Subject: College Park Elementary School HVAC Replacement
San Mateo - Foster City School District
Aedis Project No. 2021005.01
DSA Application #01-119530

ADDENDUM NO. 1

College Park Elementary School HVAC Replacement
San Mateo – Foster City School District
Aedis Project No. 2021005.01

6 TYPICAL SOUND TREATED NONRATED WALL

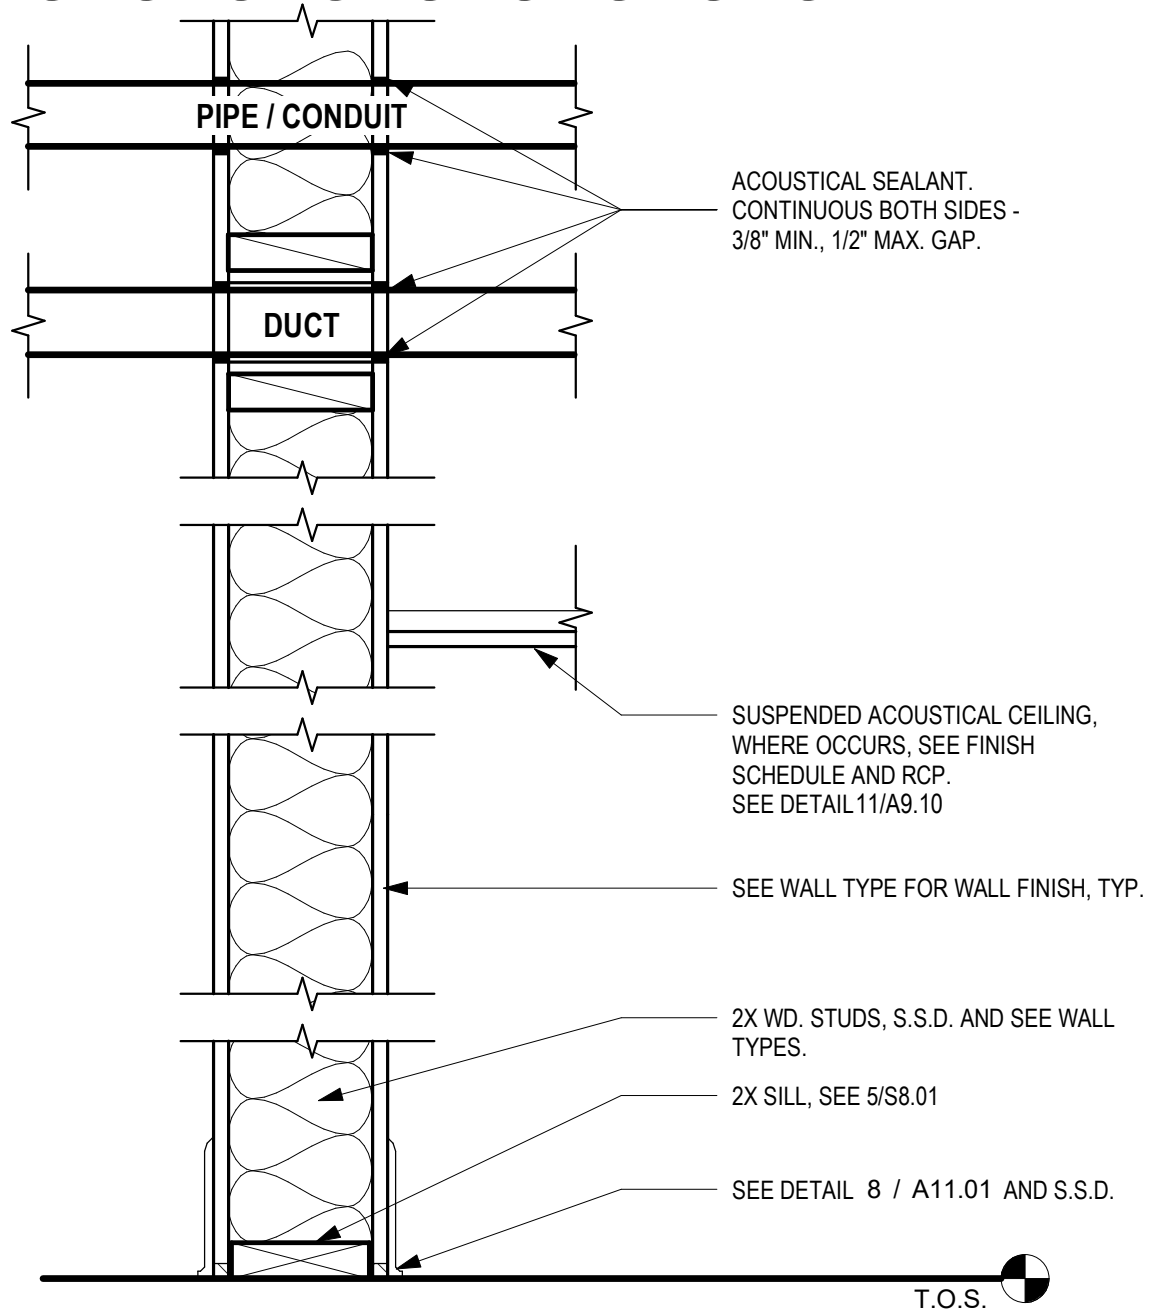
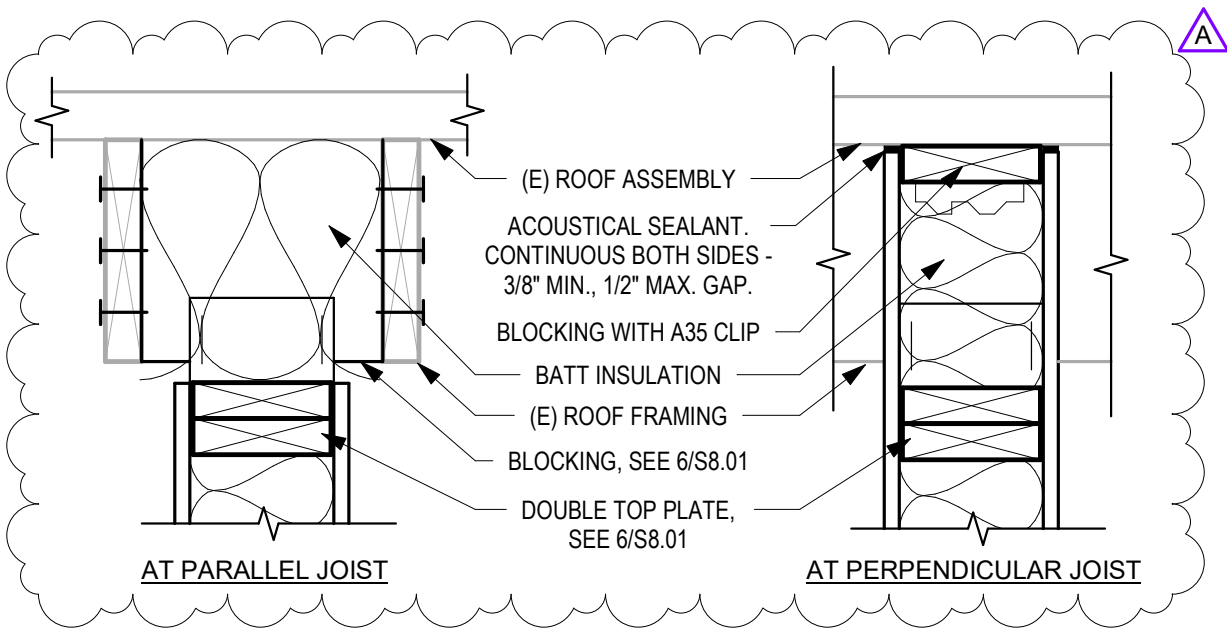
Revise: Detail 6 per AD1-A9.10B

DOOR TYPES
SCALE: 1/4" = 1'-0"

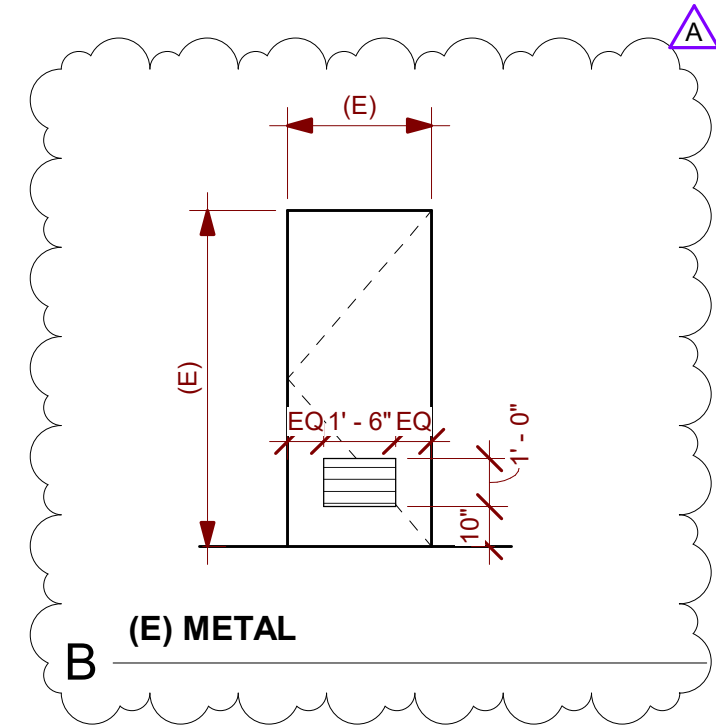
Add: Doors 210a, 308a & 413a to Door Schedule per AD1-A11.01

Add: Door Type B per AD1-A11.01

Add: Door Schedule Comment per AD1-A11.01

PROVIDE NEW LOUVER AT EXISTING DOOR. CUT AND PREP AS REQUIRED. PAINT LOUVER TO MATCH DOOR.

4 FLOOR PLAN - ENCLOSURE
MP2.02 SCALE: NONE

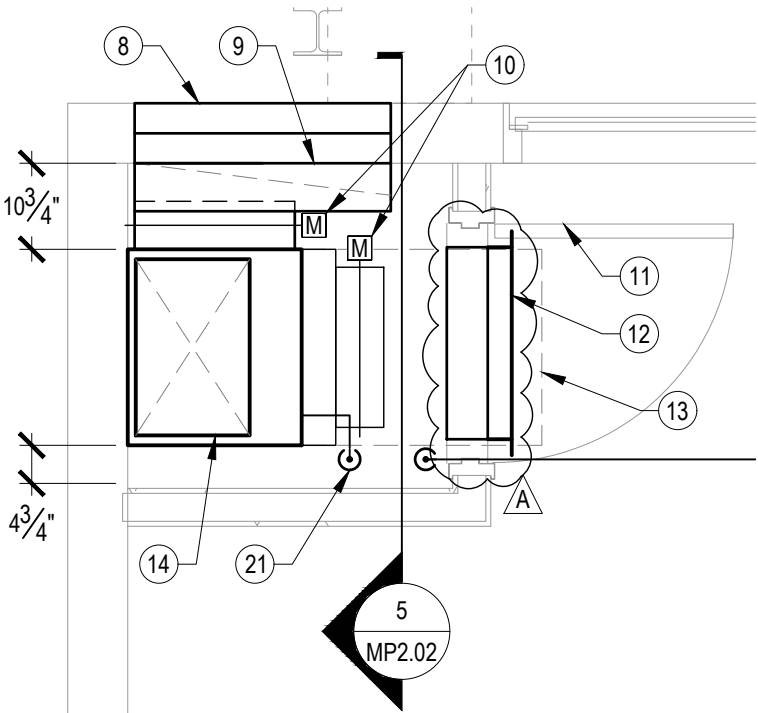
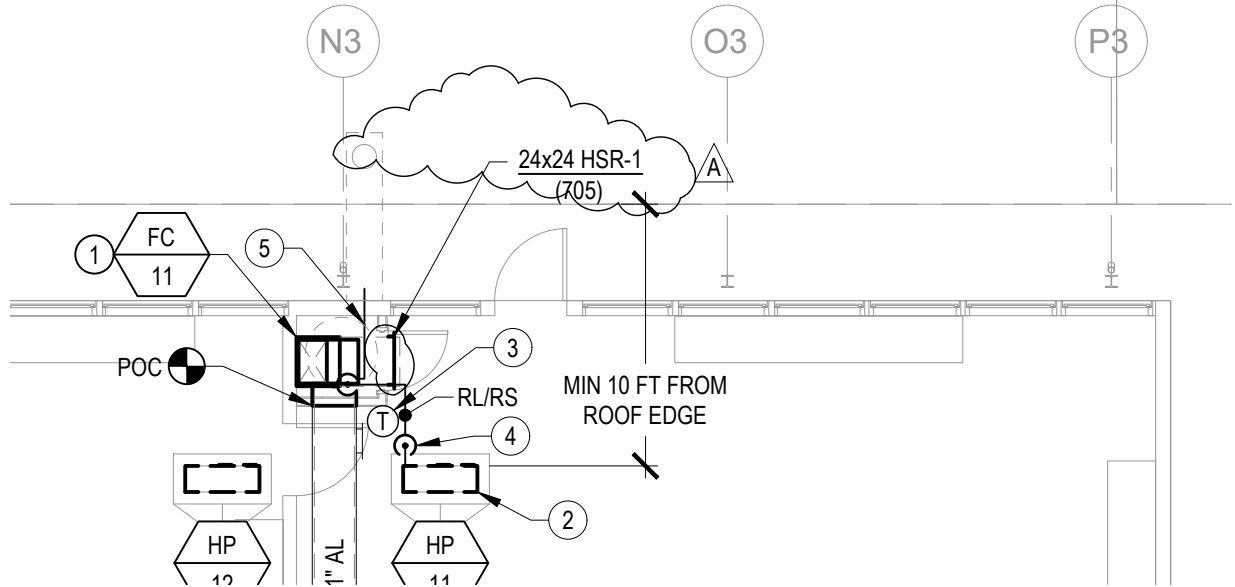
Revise: Size of Return register HSR-1 per AD1-MP2.02a

Revise: General Note #4 per AD1-MP2.02a

Add: General Note #7 per AD1-MP2.02a

Revise: New Sheet Note #12 per AD1-MP2.02a

12. 24"x24" RETURN REGISTER HSR-1 ABOVE ENCLOSURE DOOR. INSTALL WITH GRILLE SILENCER.

1 FLOOR PLAN - WING 4 - NEW - MECHANICAL & PLUMBING
MP2.02 SCALE: 1/8" = 1'-0"

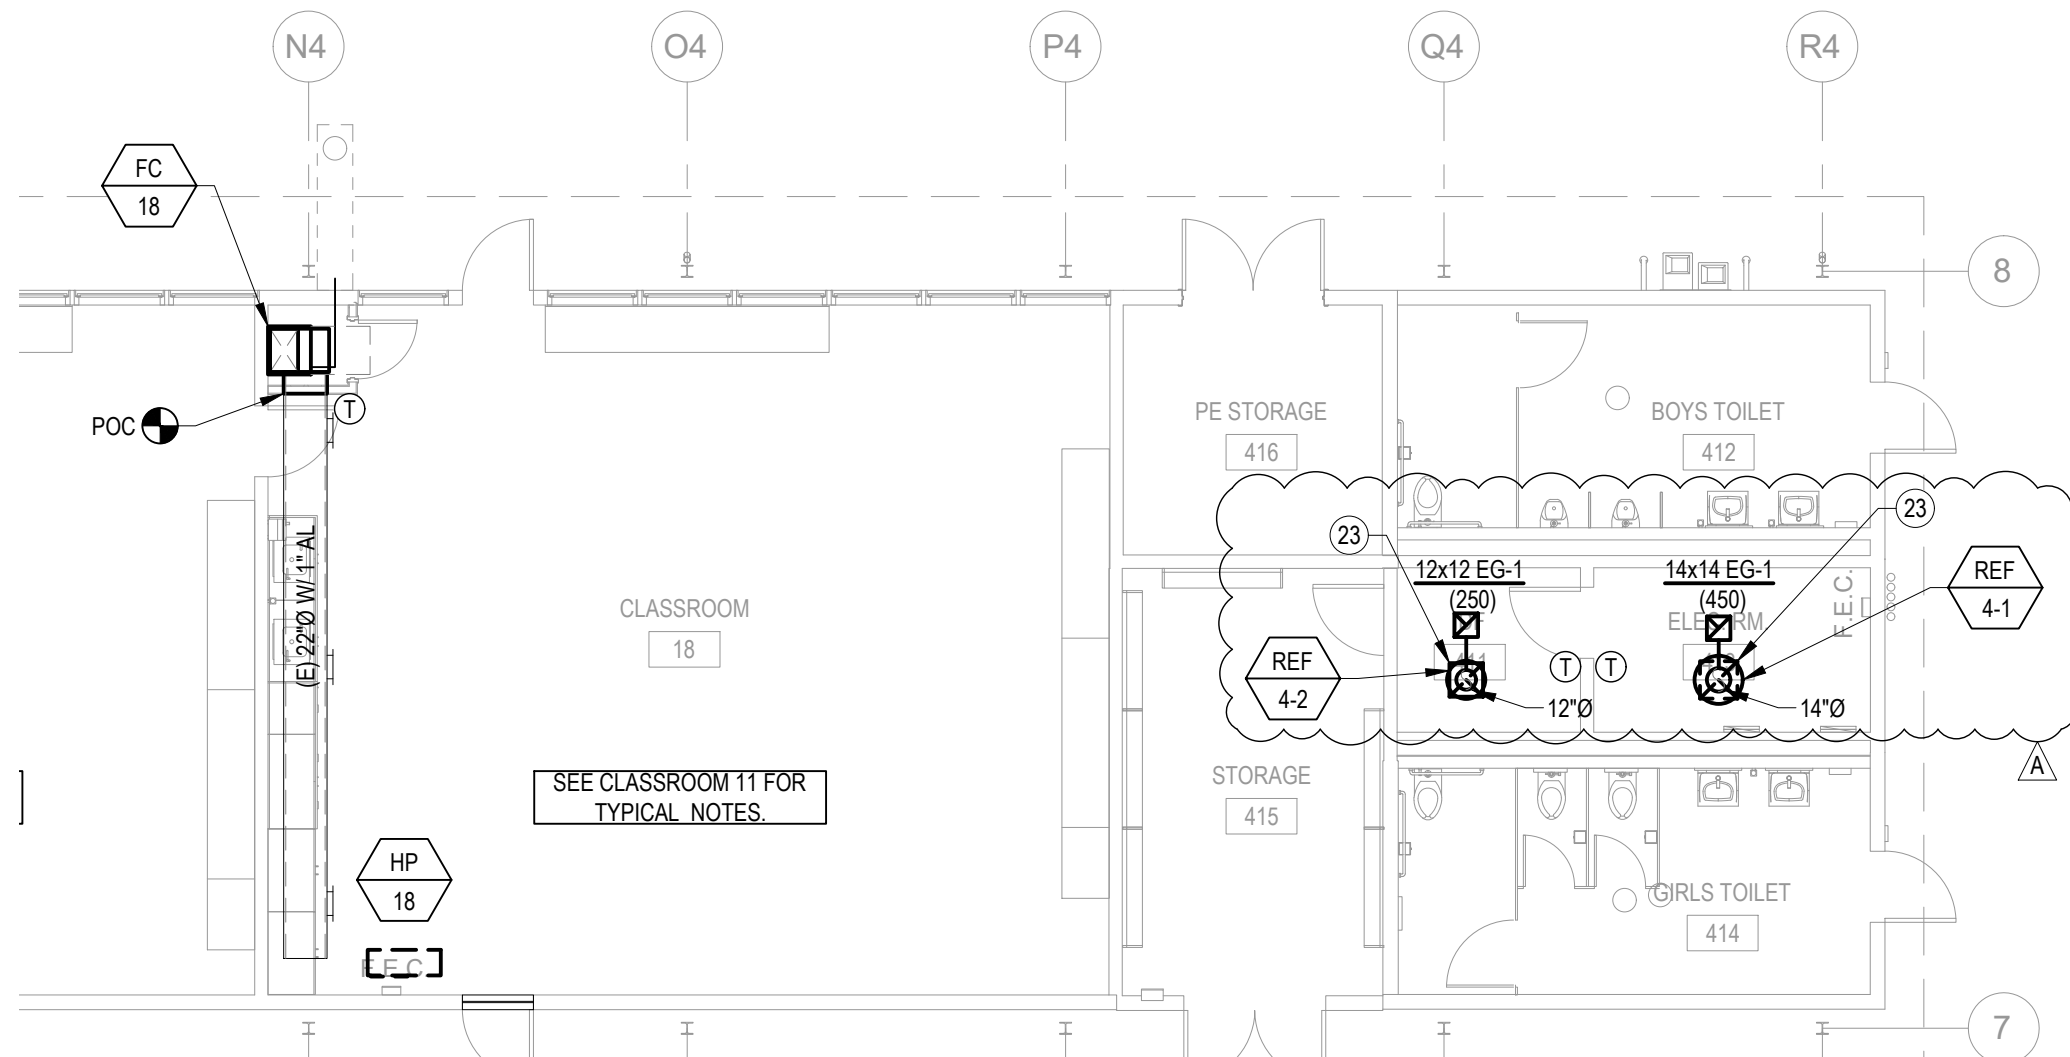
Add: REF-4-1 and REF-4-2 per AD1-2.02b

Add: New Sheet Note #23 per AD1-2.02b

23. INSTALL EXHAUST FAN ON ROOF.

SHEET # **AD1-
MP2.03**

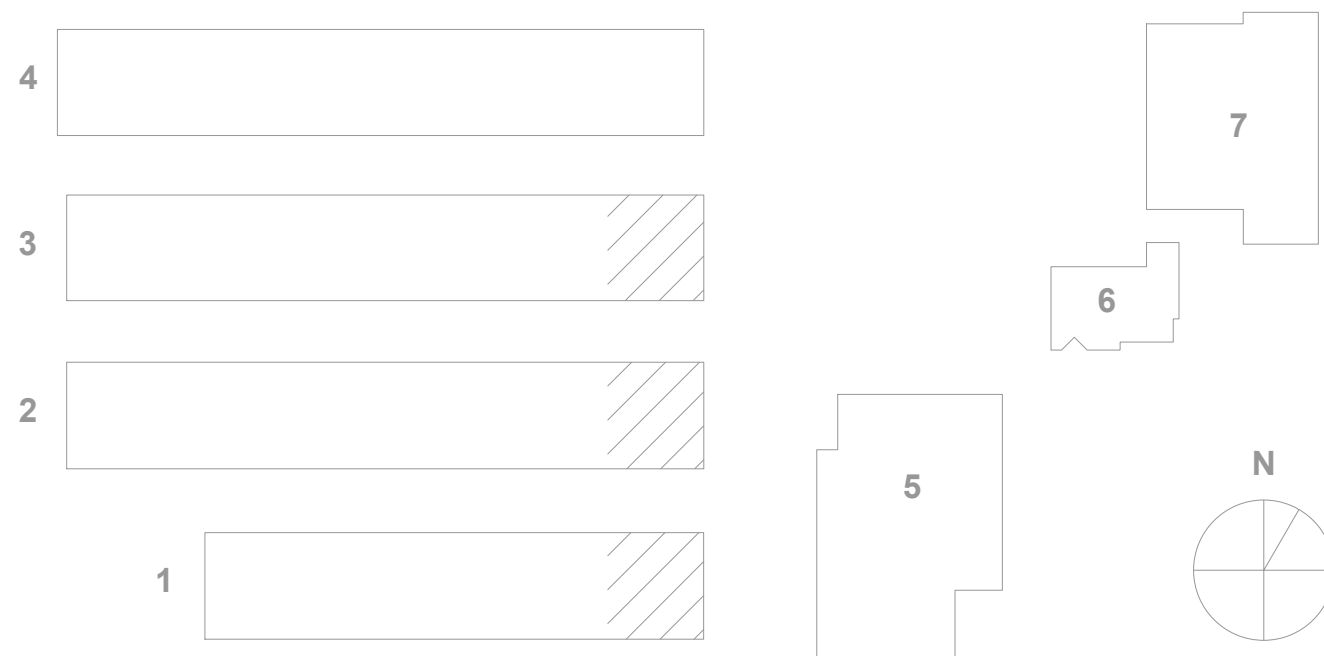
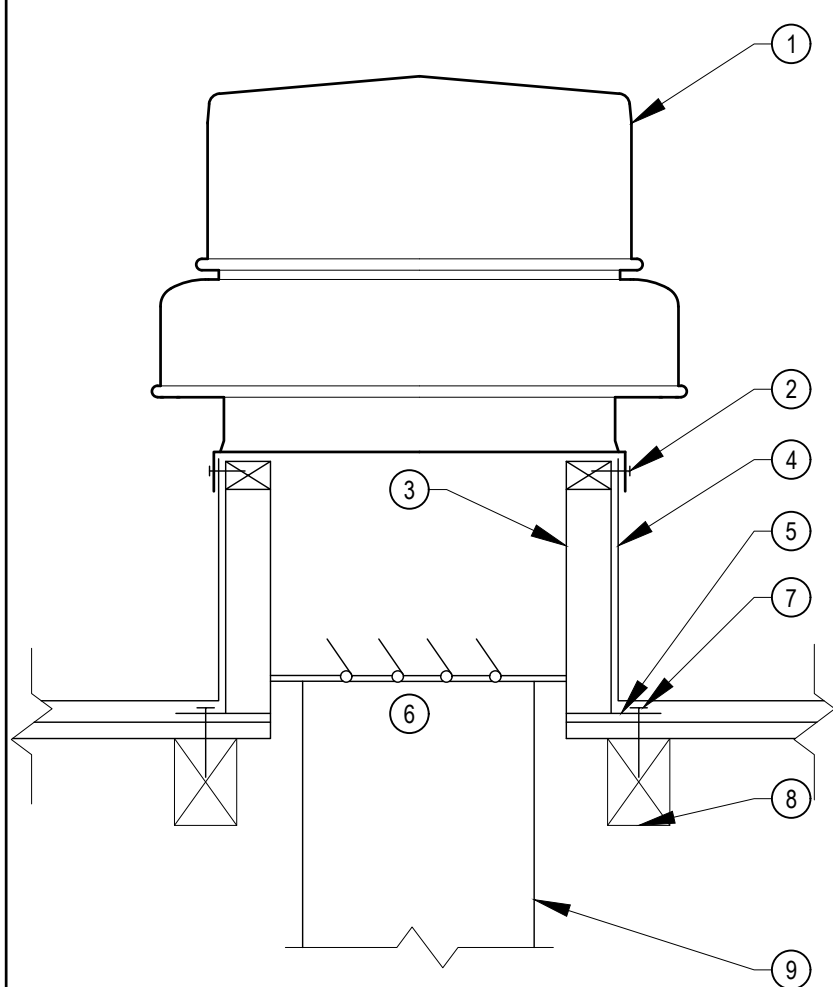
Add: New sheet in its entirety per AD1-MP2.03

1. INSTALL EXHAUST FAN ON ROOF.

9 EXHAUST FAN MOUNTING

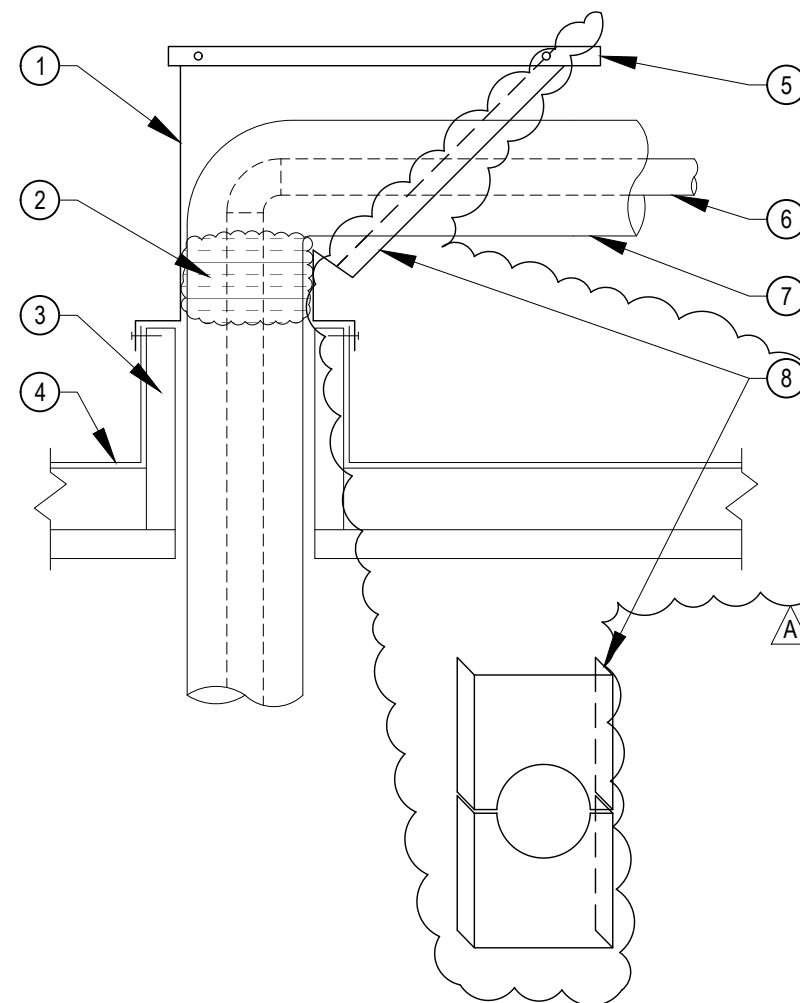
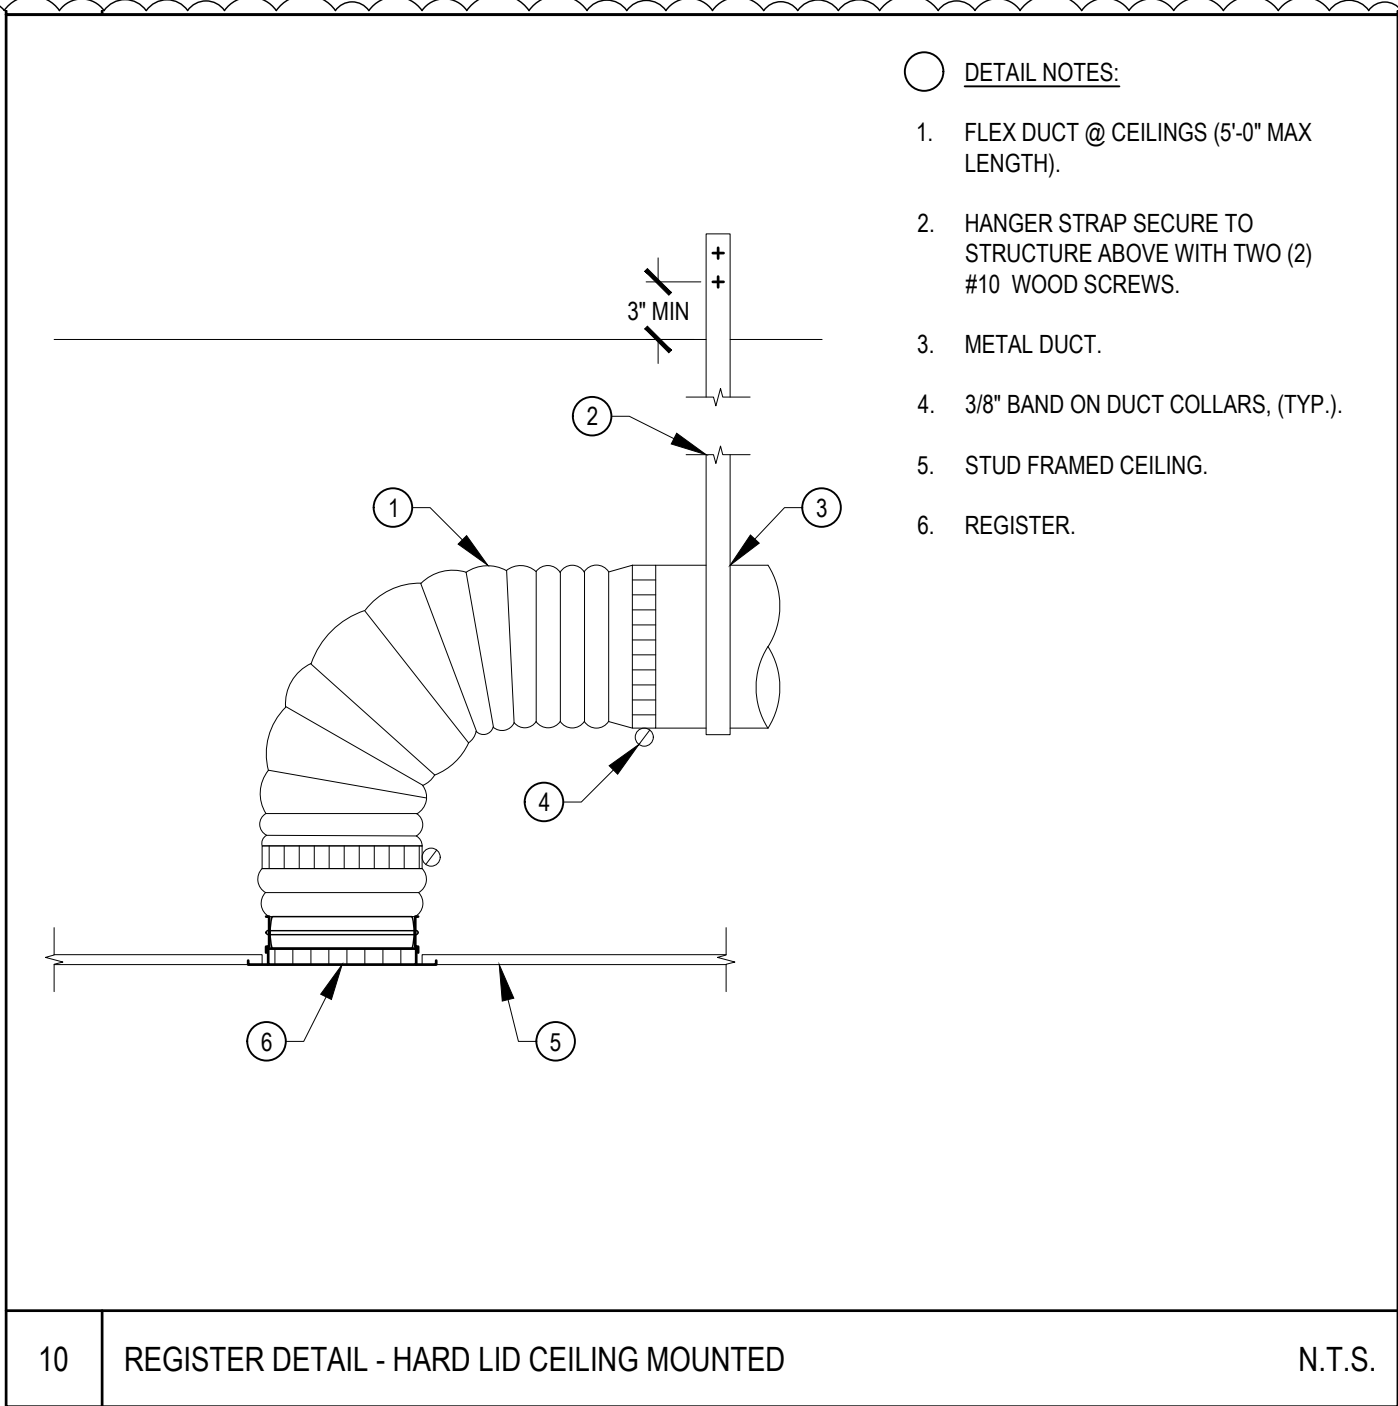
Revise: Detail #4 – Piping Roof Jack per AD1-MP6.01

Add: Detail #9 – Exhaust Fan Mounting per AD1-MP6.01
